A. Affected Silicon Revision

This document details known errata for the following silicon:

Product	Revision	Description	Status
PEX8605	AA	4-Lane, 4-Port PCI Express Switch	Full Production
PEX8605	AB	4-Lane, 4-Port PCI Express Switch	Full Production

Document	Version	Description	Publication Date
PEX8605 Data Book	1.3	Data Book	November, 2012

Figure 1. An example circuit to create a delayed version of PEX_PERST# for downstream devices.

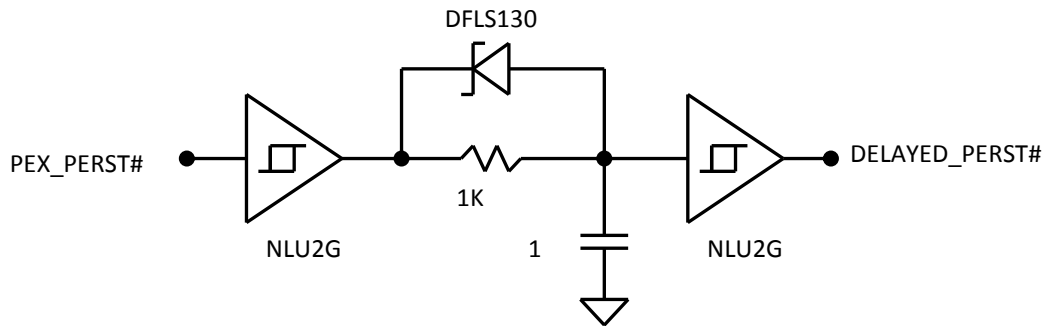
Err_5. PEX_REFCLK_OUTpx/nx Clock Outputs is not Guaranteed Until 900 us After PEX_PERST# De-assertion

At initial power-on, valid clock may not appear at the PEX_REFCLK_OUTpx/nx output pins, even while a valid clock is present on the PEX_REFCLKp/n input pins, until 900 us after PEX_PERST# input pin is de-asserted. Because PCI Express devices attached to the downstream ports of the switch require their input clocks to be valid for 100 us prior to de-assertion of PERST# (per PCI Express specifications), it is not possible for both PEX8605 and its downstream devices to share a common reset line.

Workaround options may vary depending on the application. For any workaround implemented, PERST# de-assertion on the downstream device must be delayed by at least 1 ms from PEX_PERST# input.

1. Use separate signals for driving PEX_PERST# and PERST# for the downstream devices. Design the system so that PERST# on the downstream device remains asserted at least 1 ms after PEX_PERST# is de-asserted.
2. Use GPIO[3:1] output pins for driving PERST# to downstream devices. In this option, firmware must first configure the PEX8605 GPIO pins (default function for GPIO[3:0] pins is LANE_GOOD[3:0]), program the GPIO pin to toggle low then high, and then configure downstream devices.
3. Create a delayed version of PEX_PERST# using a delay circuit such as the one shown in Figure 1 below. This circuit delays the rising edge of PEX_PERST# input by approximately 1 ms. Adjust resistor/capacitor values as needed to produce the required delay.
